**MONTGOMERY COUNTY HISTORIC PRESERVATION COMMISSION**  
**STAFF REPORT**

<b>Address:</b>	12 E. Melrose Street, Chevy Chase	<b>Meeting Date:</b>	5/22/2024
<b>Resource:</b>	Contributing Resource <b>Chevy Chase Village Historic District</b>	<b>Report Date:</b>	5/15/2024
<b>Applicant:</b>	Leslie McKay (Joshua Dean, Agent)	<b>Public Notice:</b>	5/8/2024
<b>Review:</b>	1066558	<b>Tax Credit:</b>	n/a
<b>Proposal:</b>	Hardscape alterations, pool alteration, fence alteration, and tree removal

**MASTER PLAN**

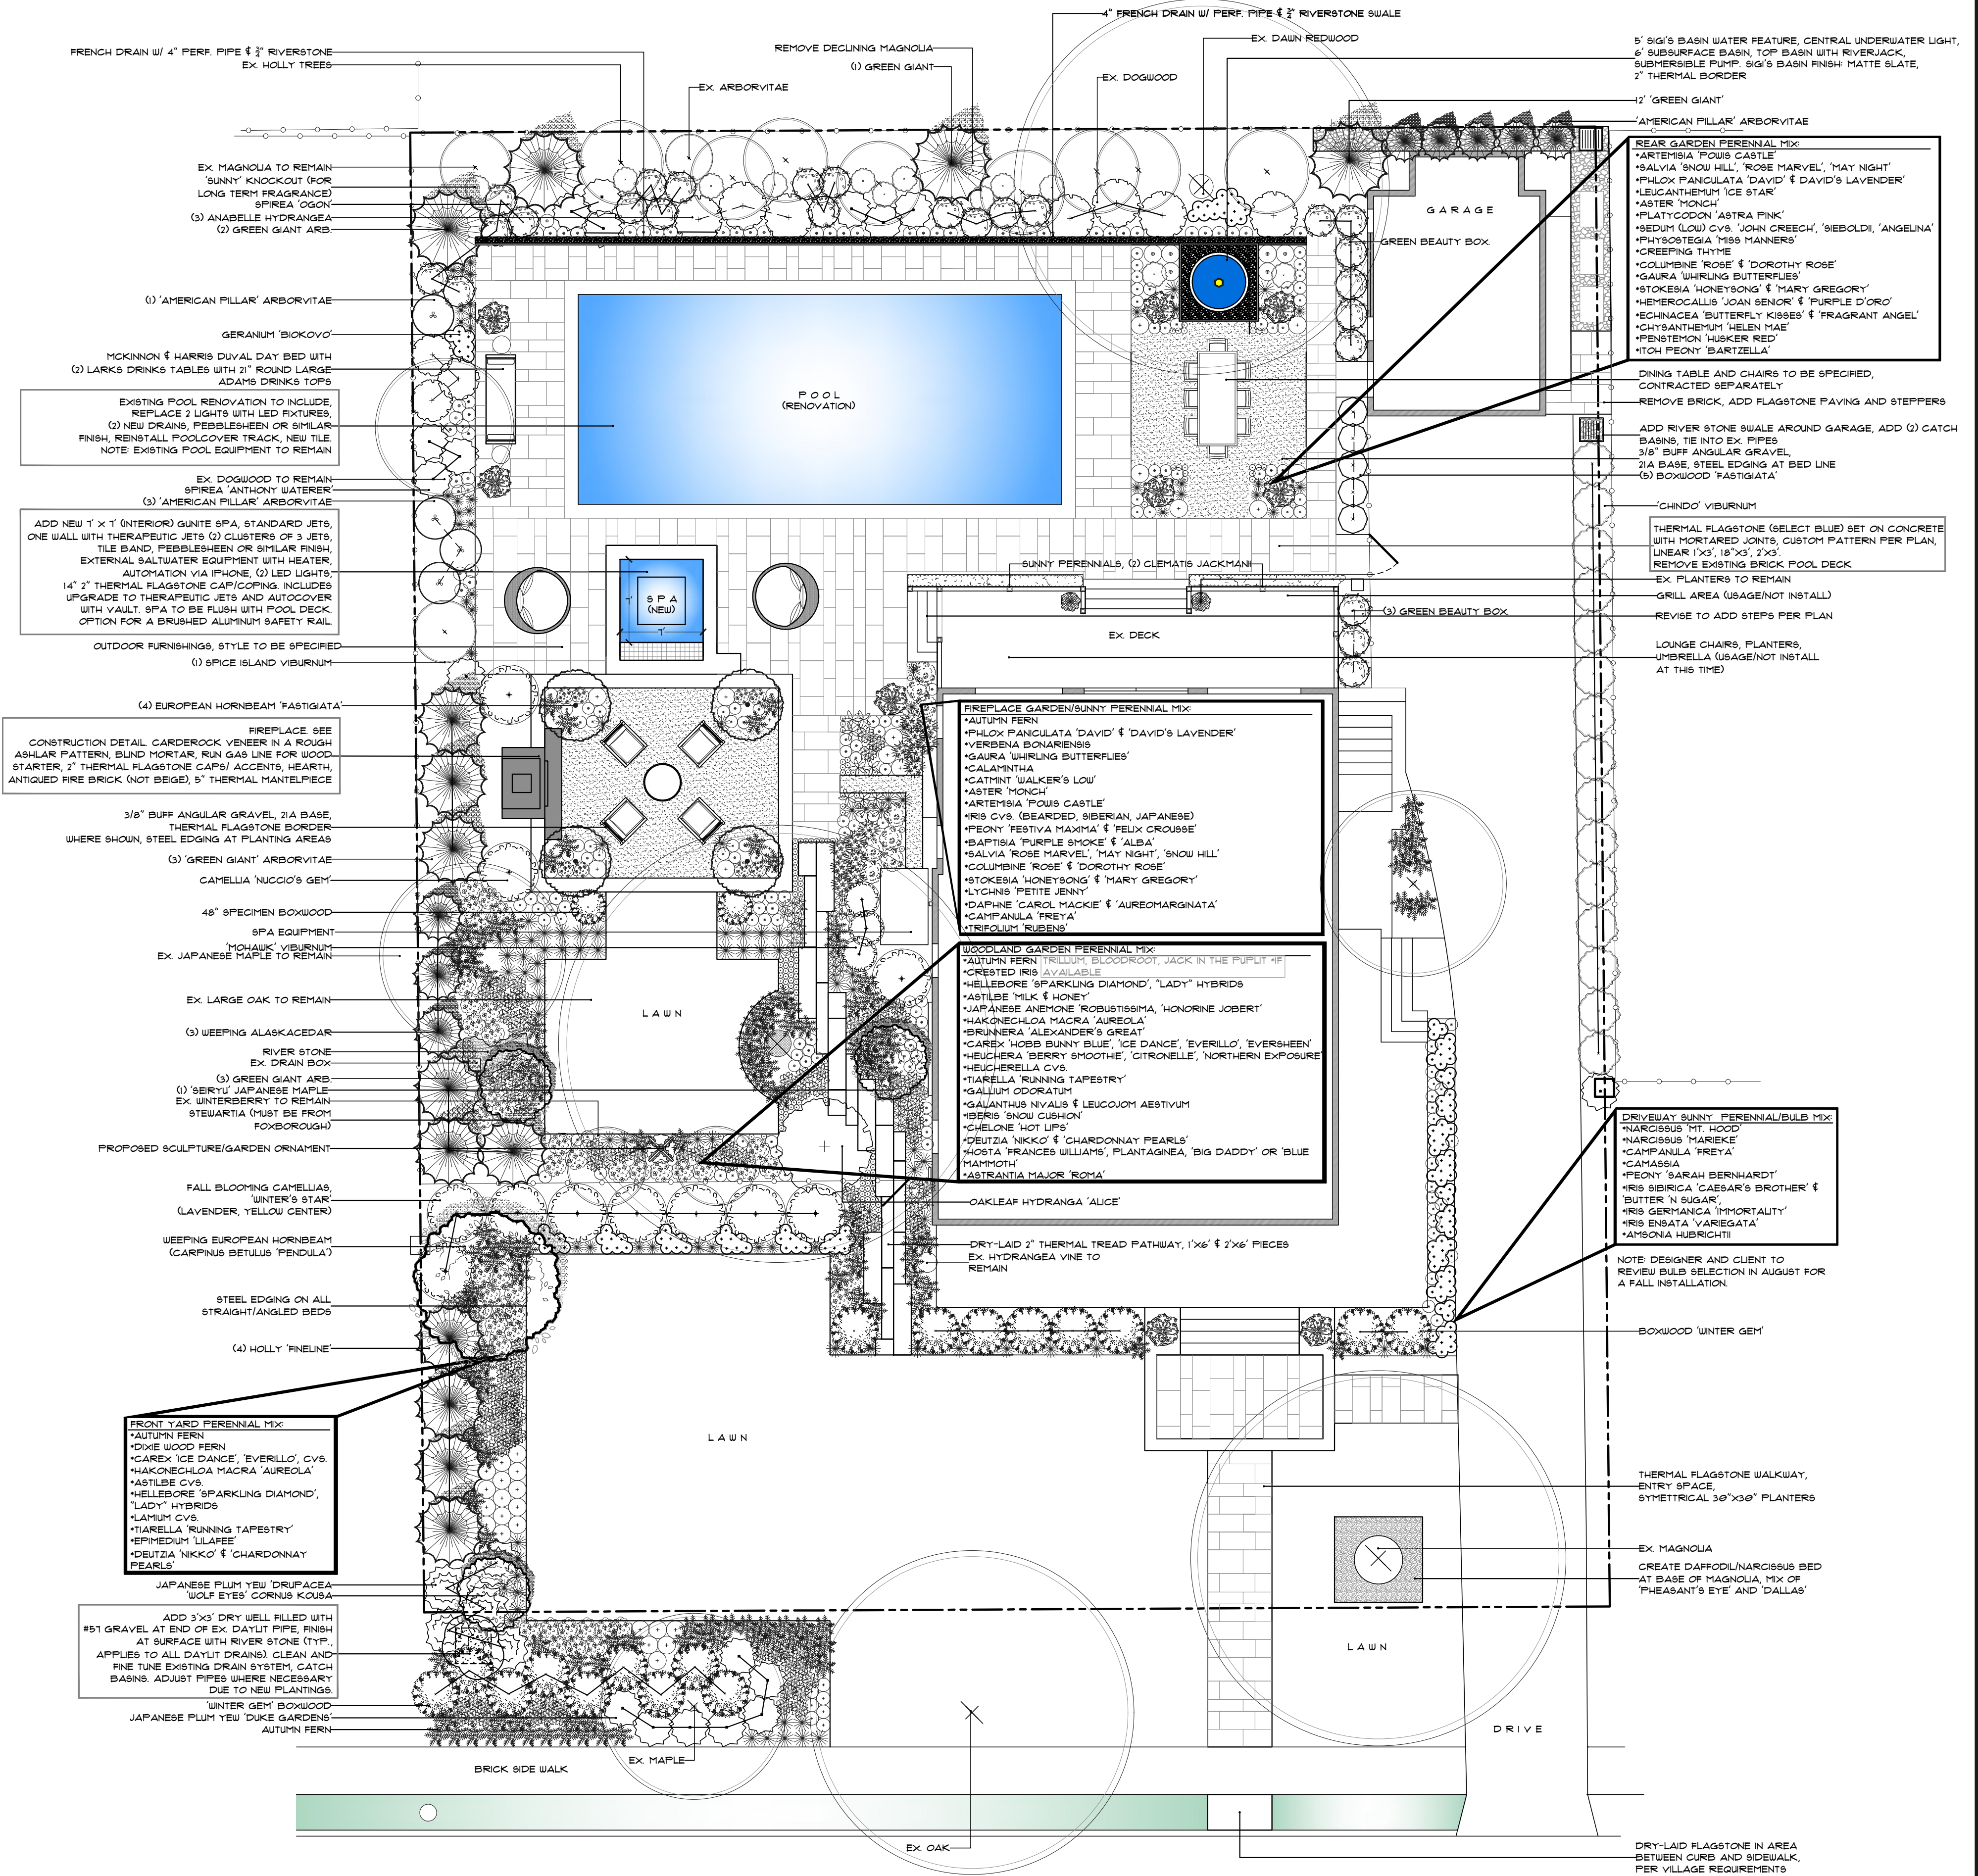
Along the east property line, the applicant proposes to construct a freestanding stone fireplace. The fireplace will be 12' 3" (twelve feet, three inches) tall and will be 9' 9 1/4" (nine feet, nine and one-quarter inches) wide at its base and narrows toward the top. The fireplace exterior will be covered in a stone veneer with flagstone caps. The applicant proposes to install a gravel area west of the proposed fireplace. The proposed gravel area measures approximately 20' × 20' (twenty feet square) and will have a flagstone border.

Under the *Design Guidelines*, the proposed fireplace should be reviewed under moderate scrutiny. Under this level of review, the primary concern is that the resource will still contribute to the historic character of the surrounding district. Staff finds this feature will be visible from the right of way, but that it will be seen as a contemporary garden feature that will not detract from the character of the surrounding district. Staff additionally finds that the structure could be removed in the future without impairing the integrity of the resource or surrounding historic district, per Standard 10. Staff further finds the adjacent gravel patio will not impact the character of the site and will not impact any existing trees. Staff recommends the HPC approve the proposed fireplace and gravel patio.
